PERRY NUCLEAR POWER PLANT
10 CENTER RD., PERRY, OHIO 44081

Information Only
New Figure

Information Only
CN=Change

Figure 2.5-33

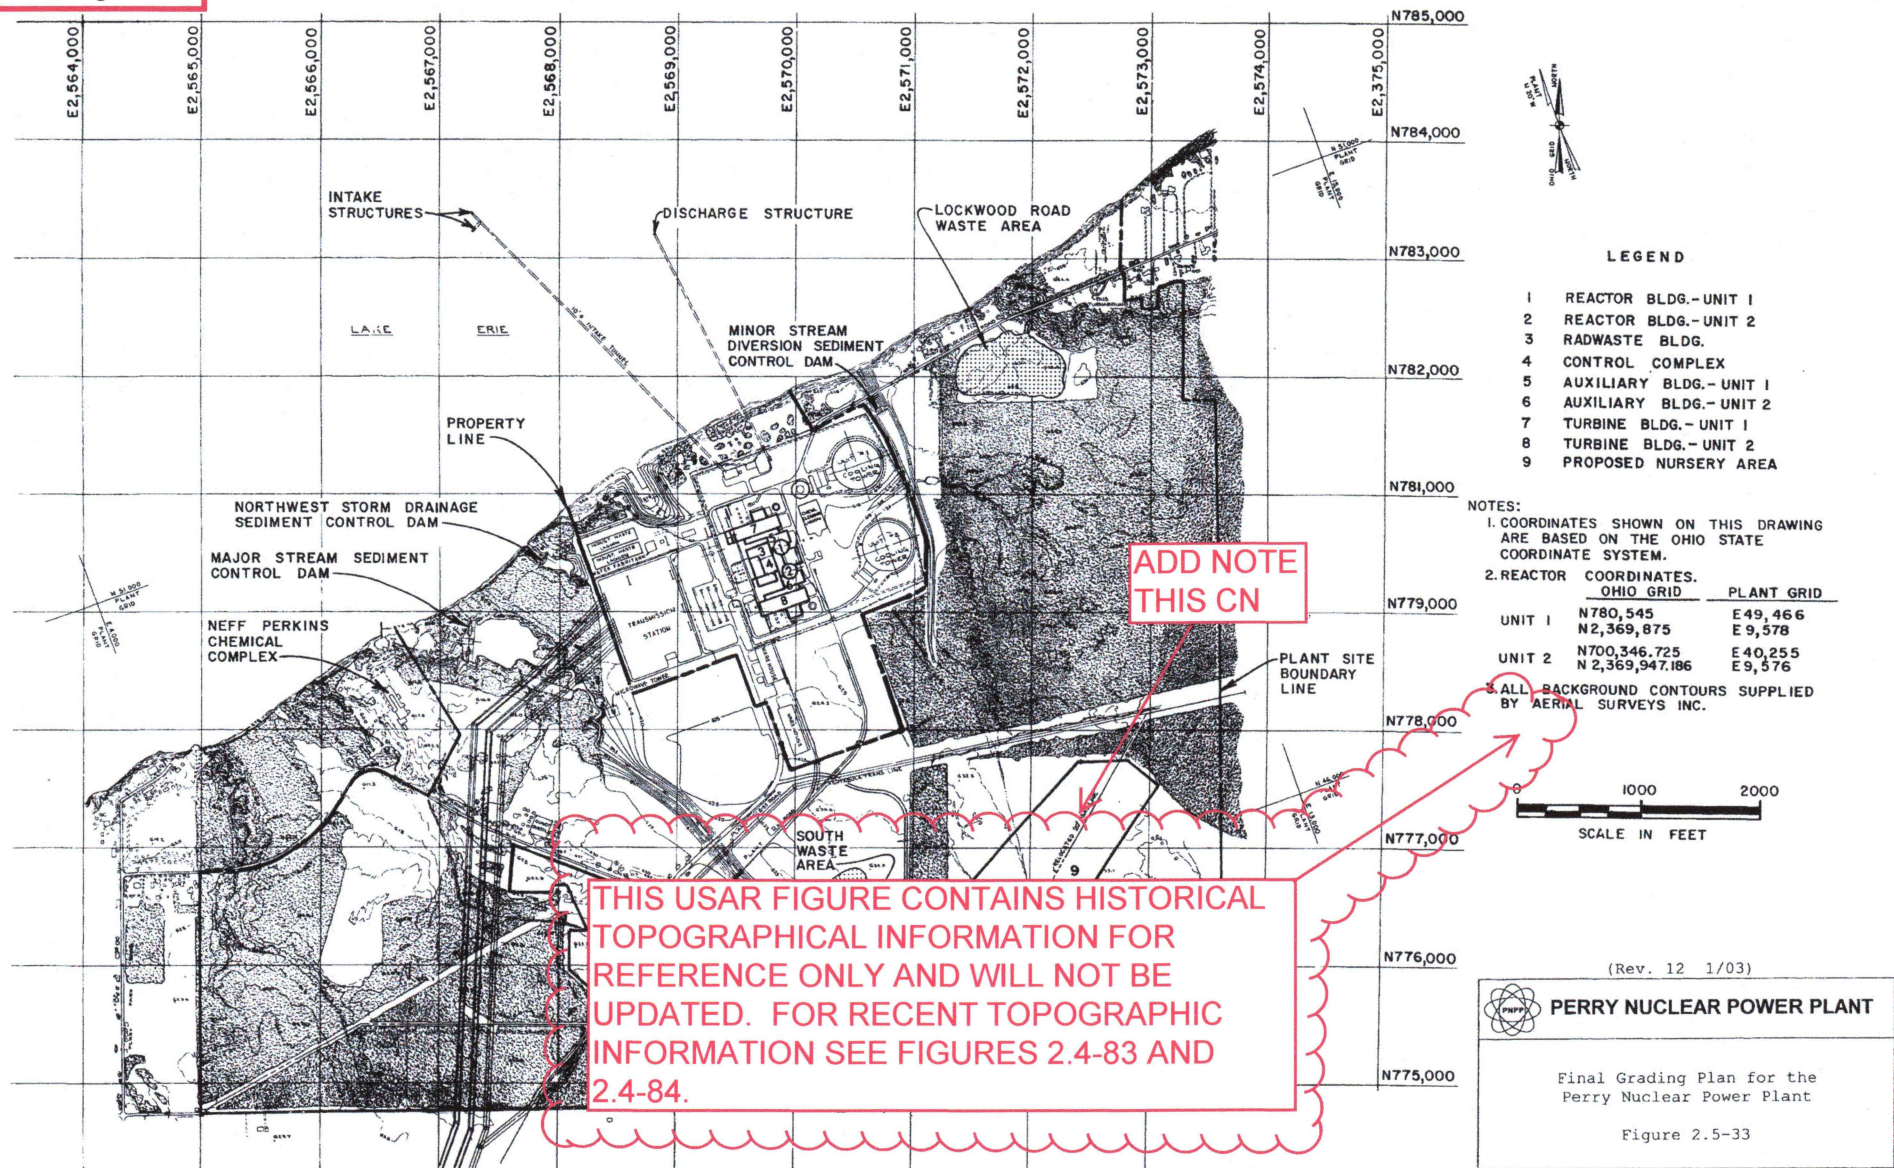
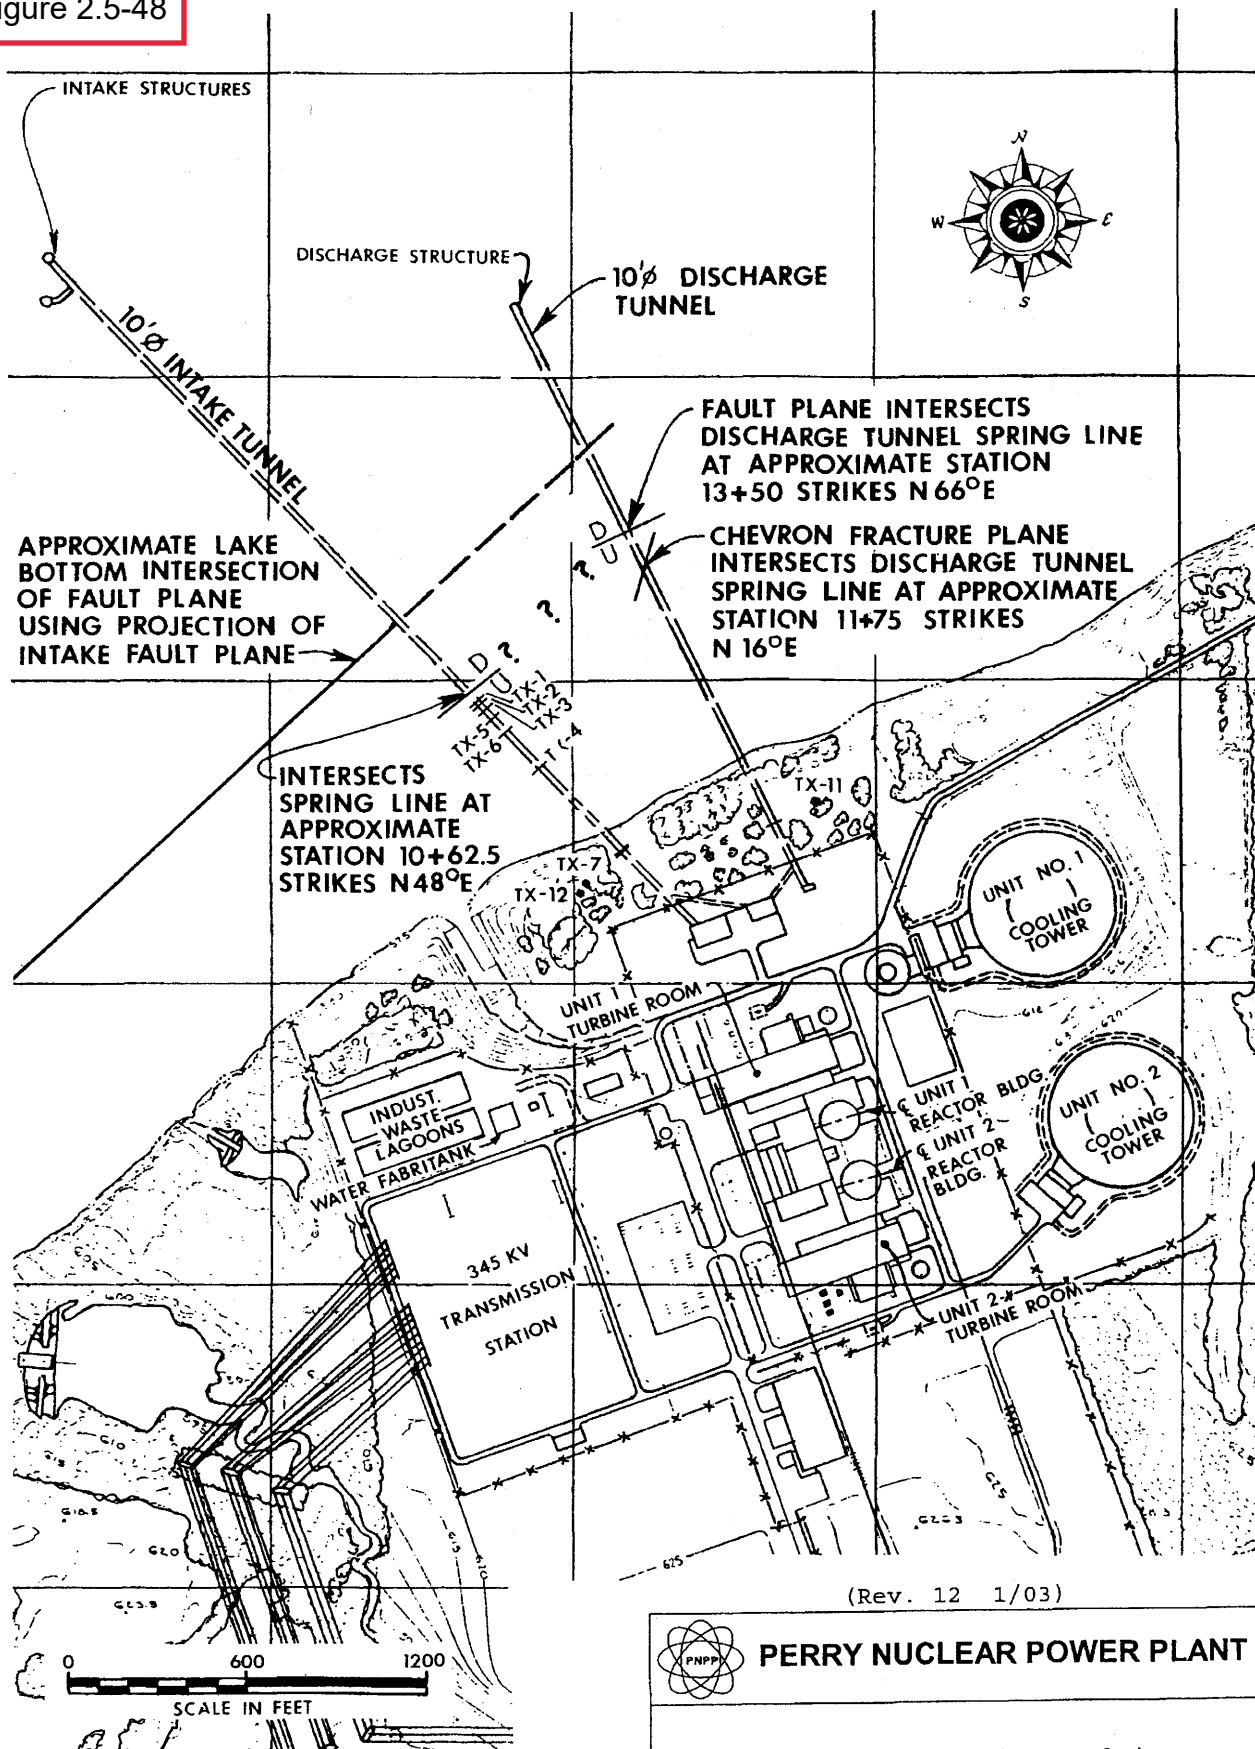
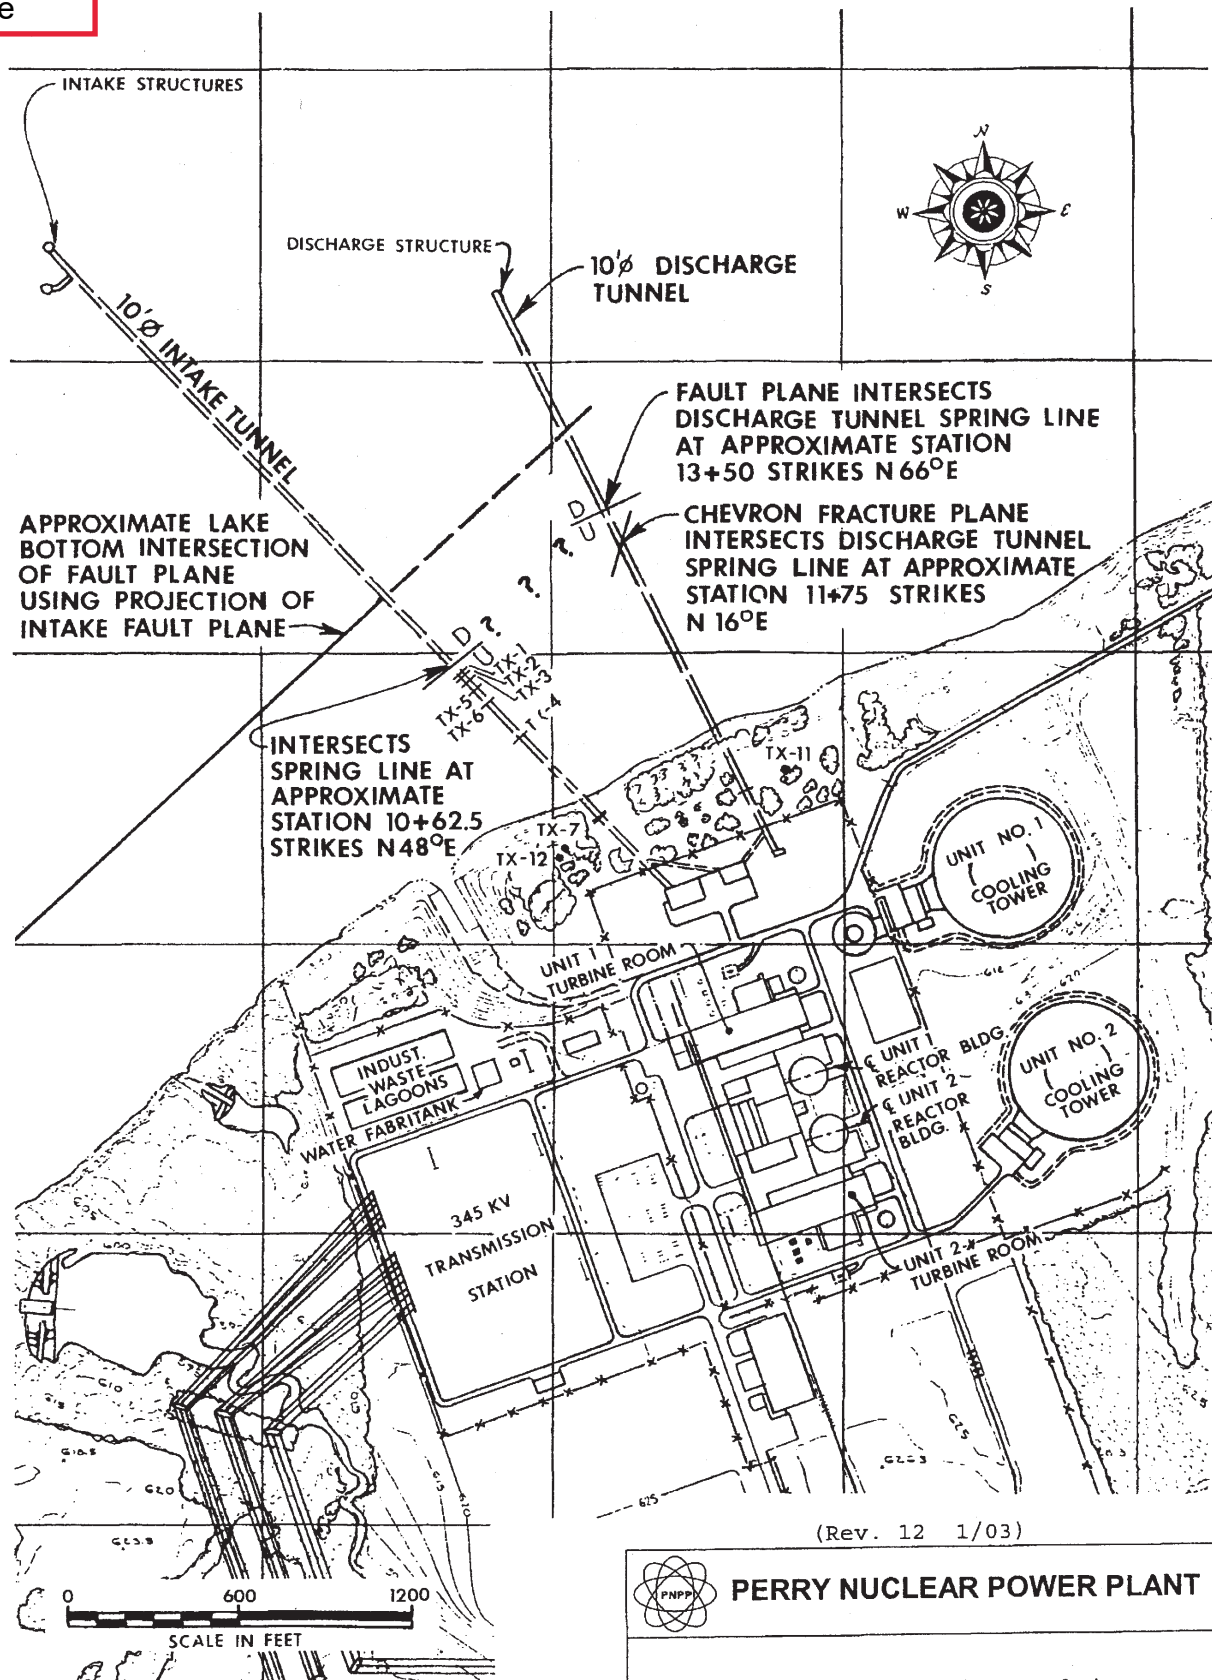
ADD NOTE
THIS CN

NOTE:
THIS USAR FIGURE CONTAINS
HISTORICAL TOPOGRAPHICAL
INFORMATION FOR REFERENCE
ONLY AND WILL NOT BE UPDATED.
